CITY OF TACOMA

ADDENDUM NO. 2

DATE: November 12, 2019

**Request for Bids Specification No. PW19-0306F
TACOMA FIRE STATION #5**

Termination of Fire Rated Shaft

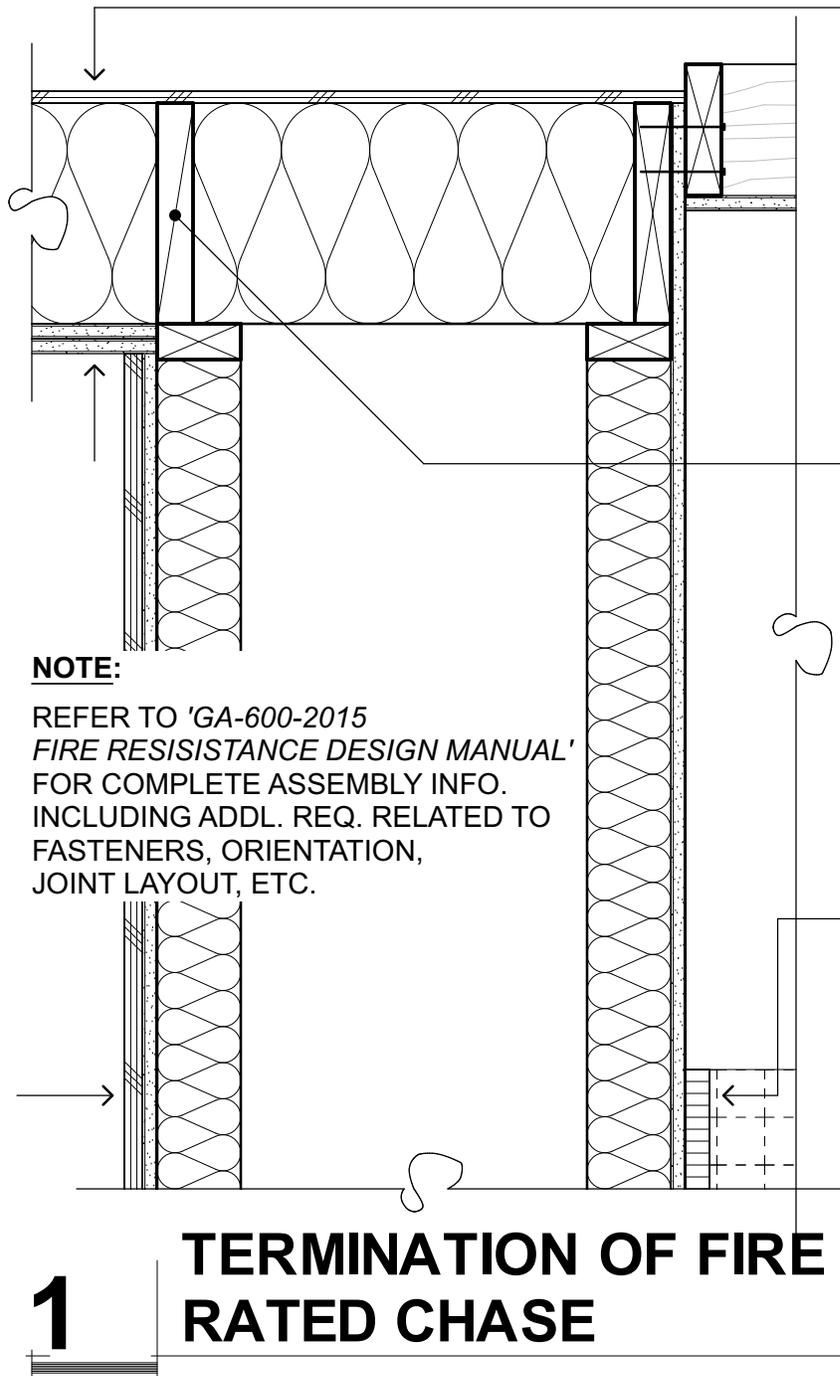
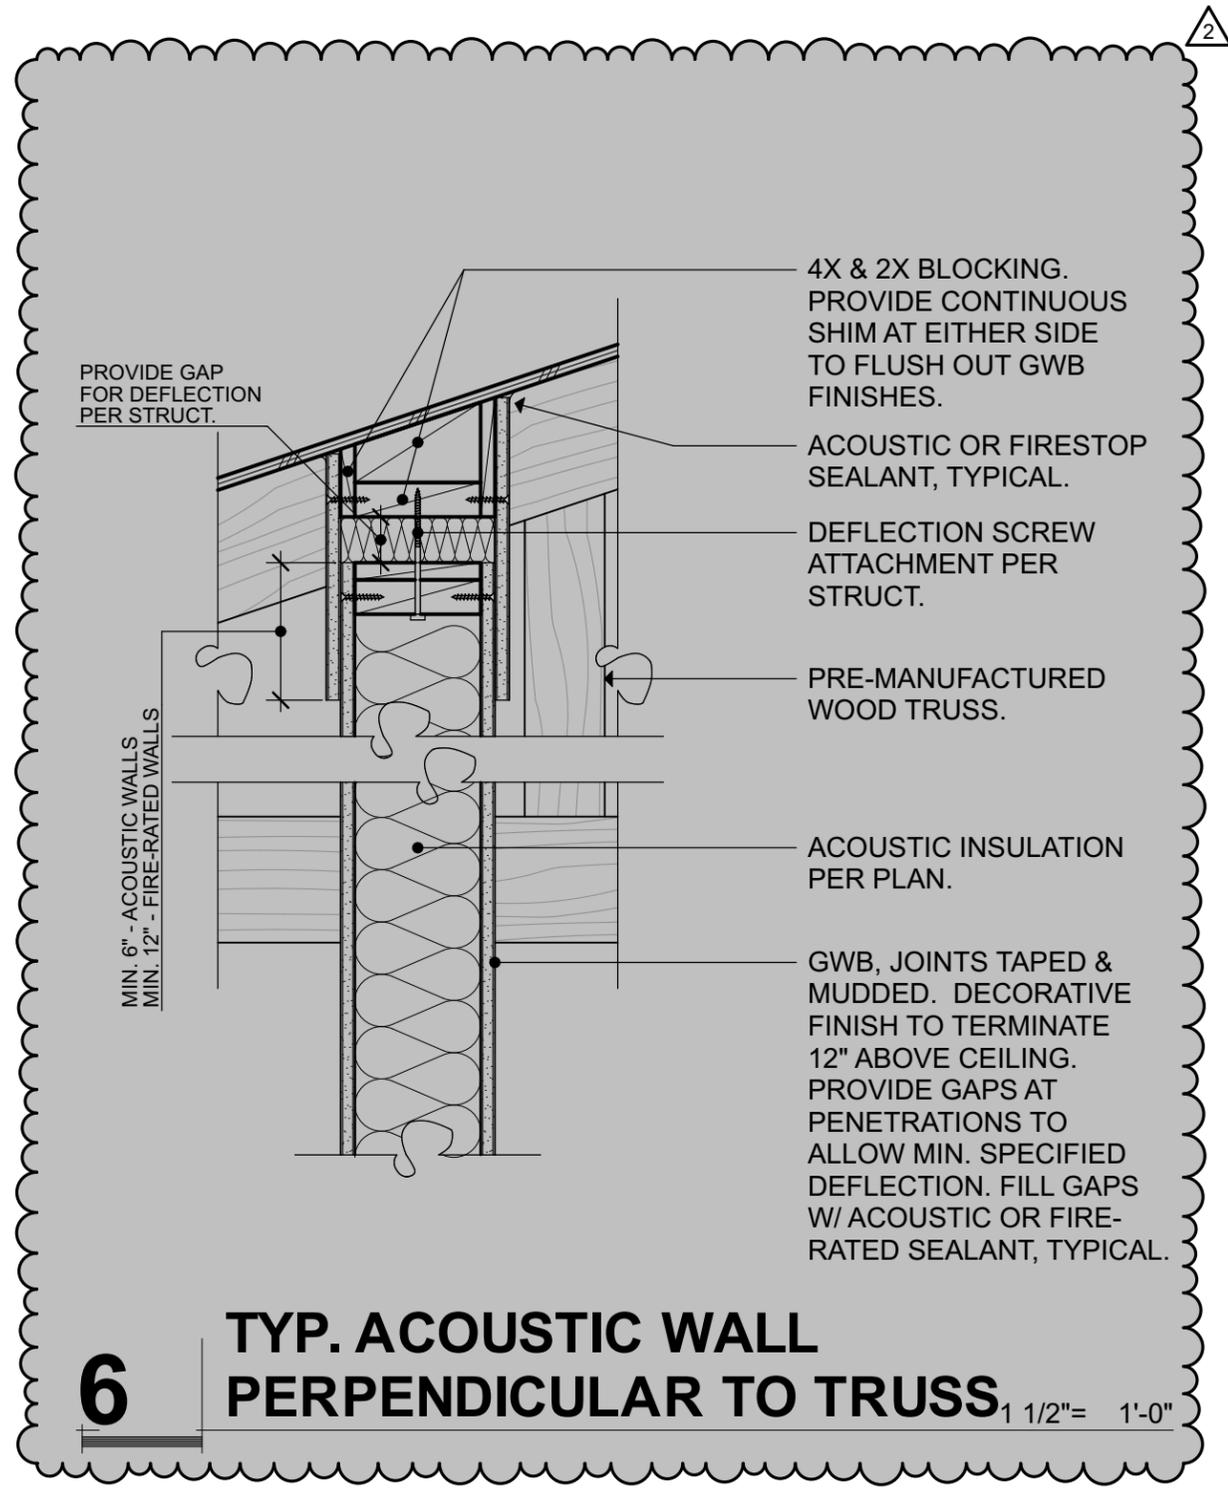
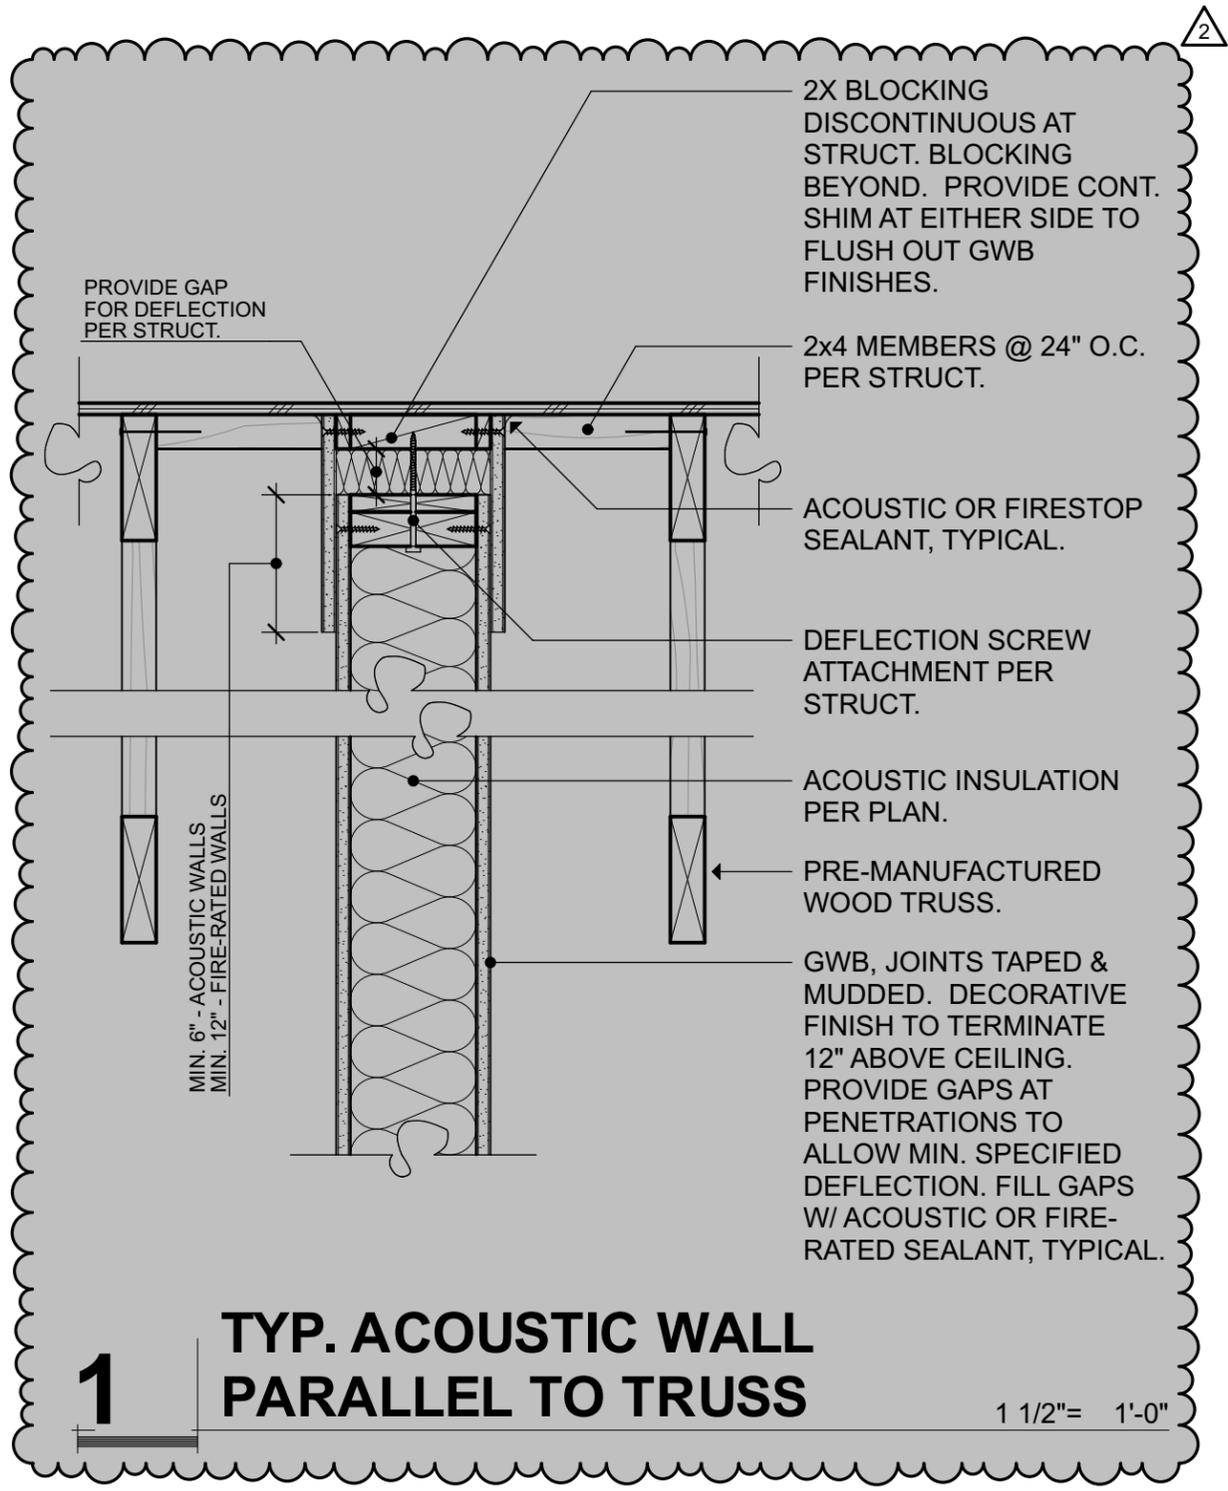
ADD: Detail to clarify termination of fire rated chase as shown on Addendum drawings SKA-5 and SKA-6

Acoustic Wall Details

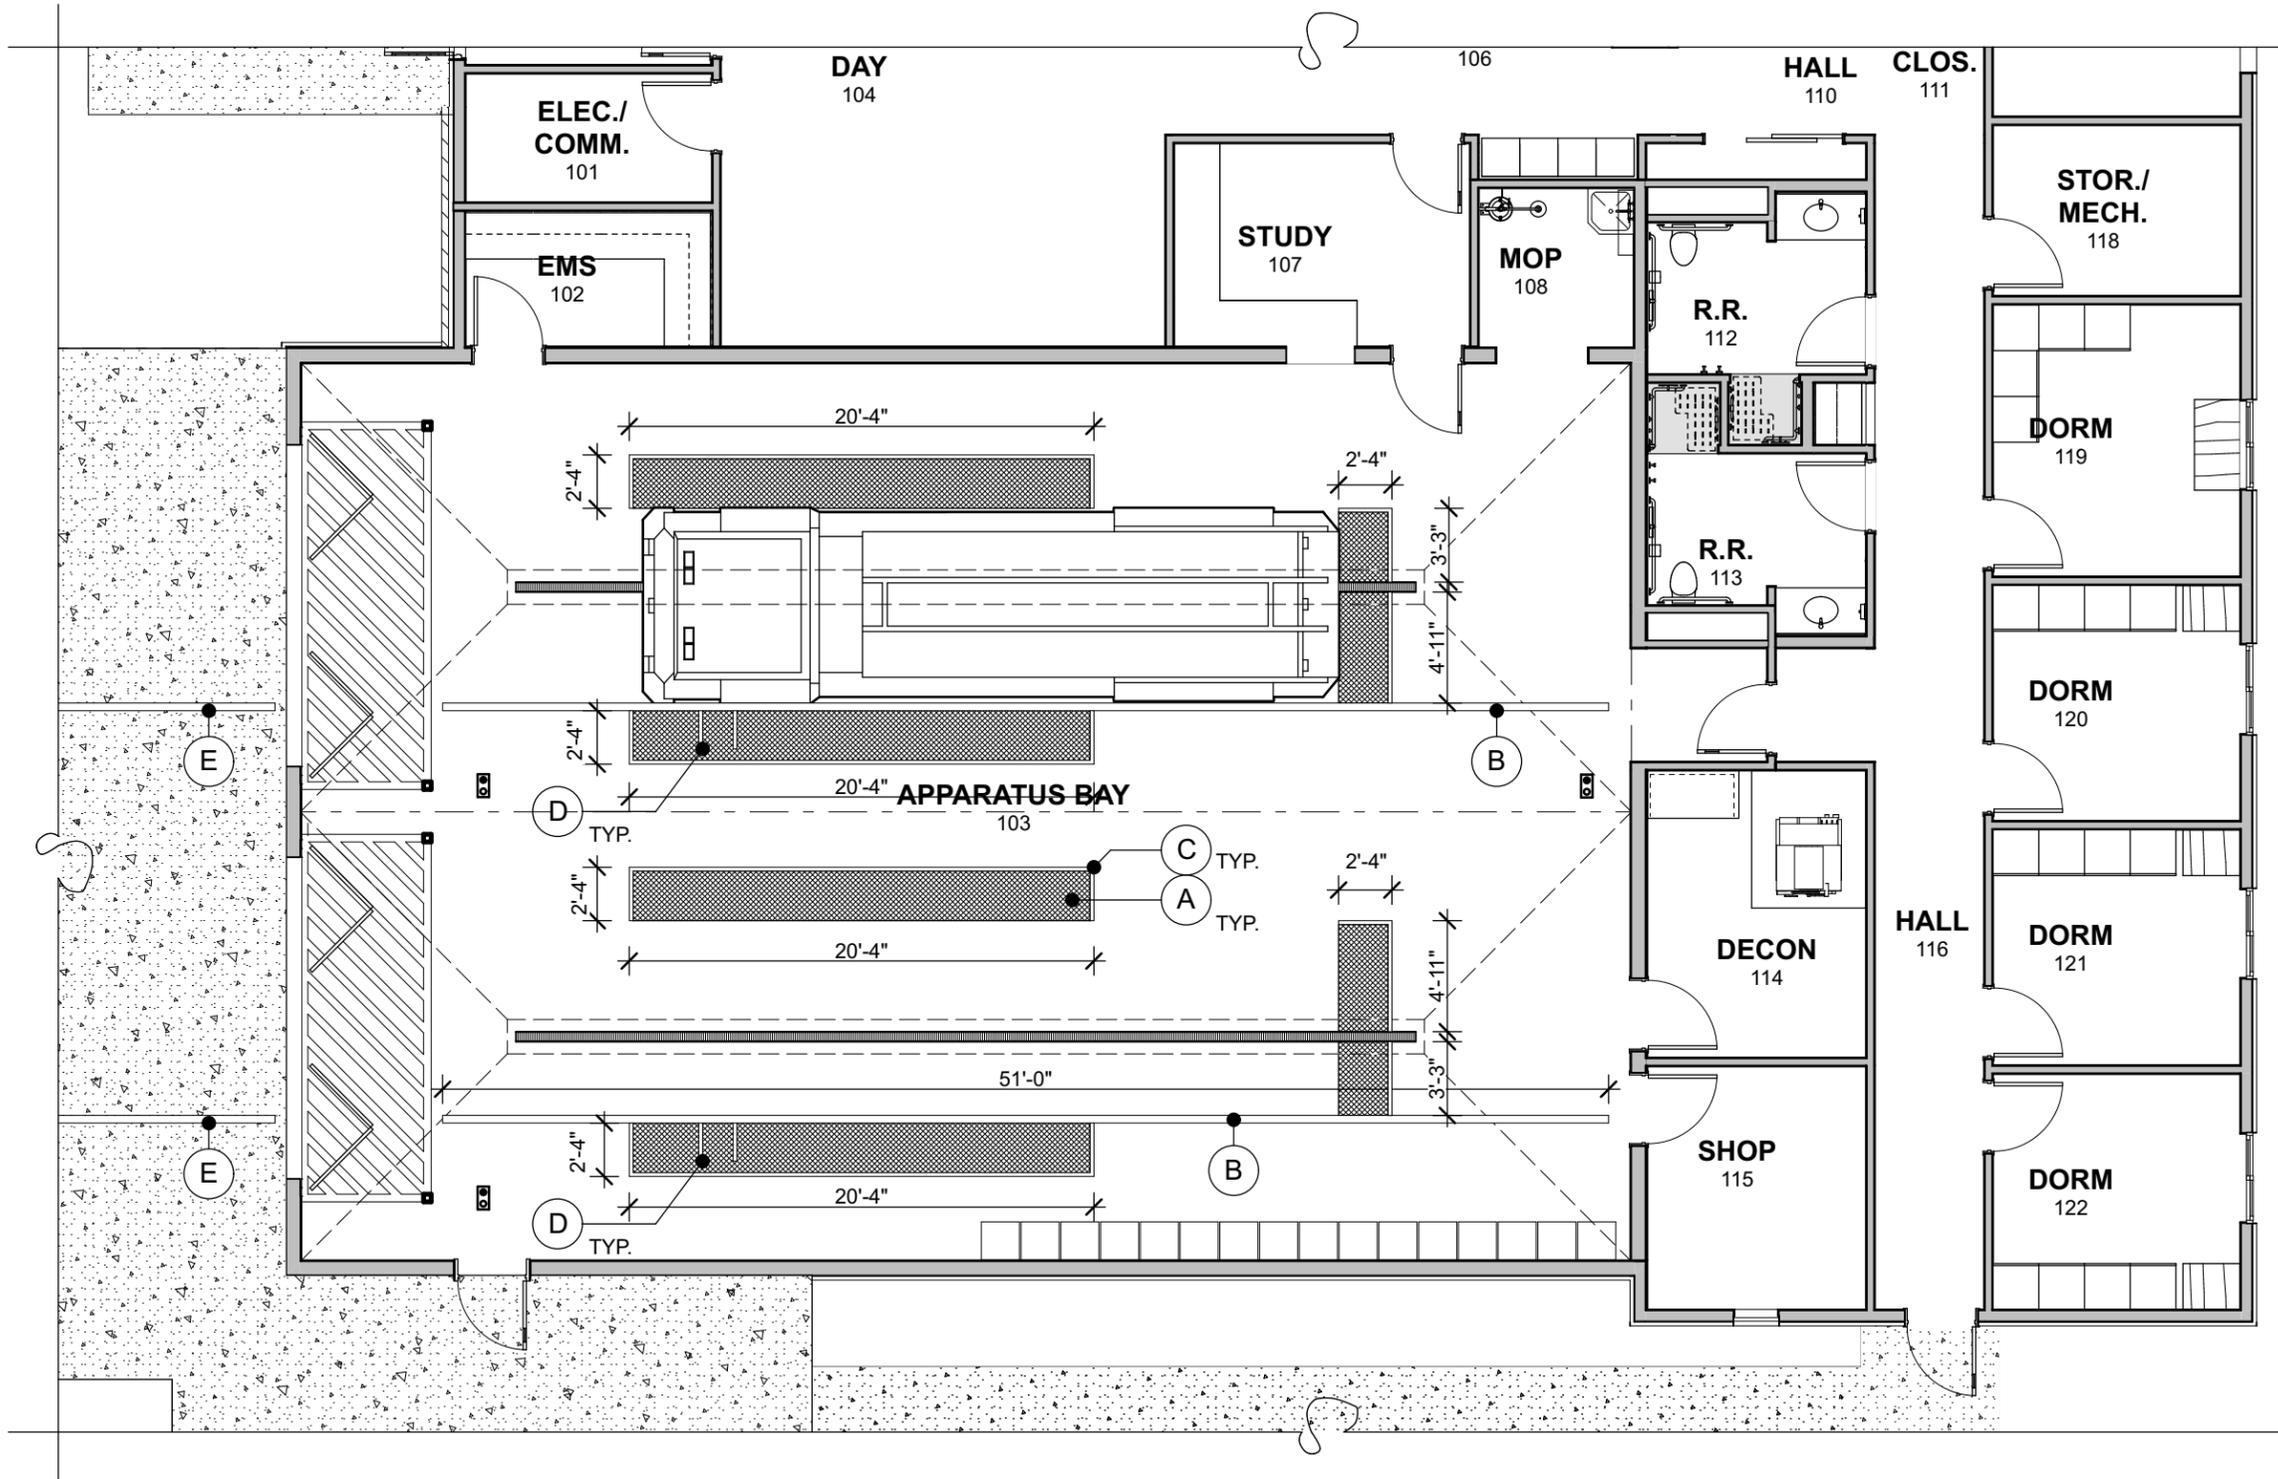
REVISE: Details 1 & 7 for wall detail changes as shown on Addendum drawings SKA-7.

1 PWT LOADING DIAGRAMS
 NO SCALE

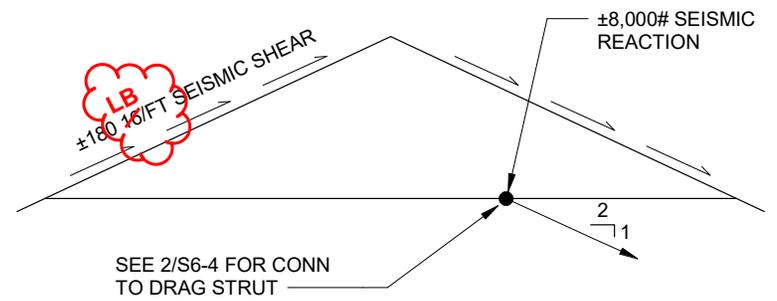
REVISE: Detail 1 as shown on Addendum drawing SSK-03

NOTES:
 1. DESIGN INTENT FOR THIS DRAG ROOF TRUSS MEMBER IS FOR IT TO BE MULTI-PLY BASED ON THE TRUSS MFR'S DESIGN, GIVEN THE LOADS BELOW.

SSK-05

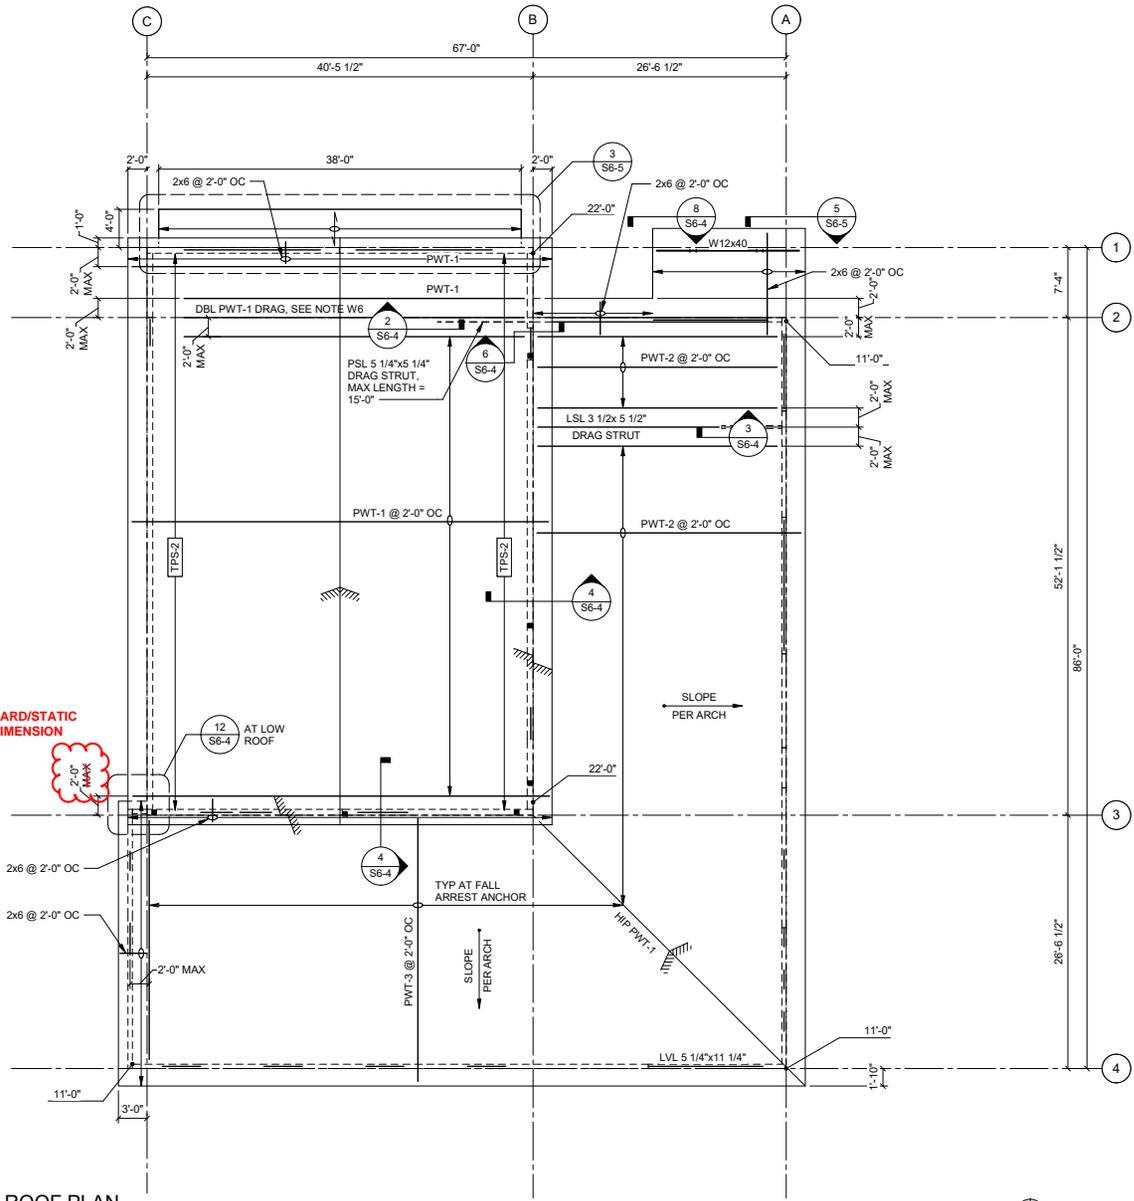
ADD: Detail 11 for Typical Interior Non-bearing Acoustical Wall Top Plate Anchorage as shown on Addendum drawing SSK-05.

1. PROVIDE 1-1/2" GAP AT LOW BAY AREA (SOUTH OF GRID B). PROVIDE 2" GAP AT HIGH BAY (NORTH OF GRID B).
2. DO NOT INSTALL NON-BEARING PARTITIONS UNTIL DEAD LOAD IS IN PLACE. AT ROOF CONSTRUCTION AND WHERE A DEFLECTION SPACE HAS BEEN PROVIDED FOR THIS REQUIREMENT MAY BE WAIVED.
3. DO NOT CONNECT CEILING GYP BOARD TO FRAMING WITHIN 24" OF NON-STRUCTURAL PARTITION WALL. OPTION FOR CONTRACTOR TO USE FASTCAP "F-CORNER" TO SUPPORT CEILING SHEATHING.
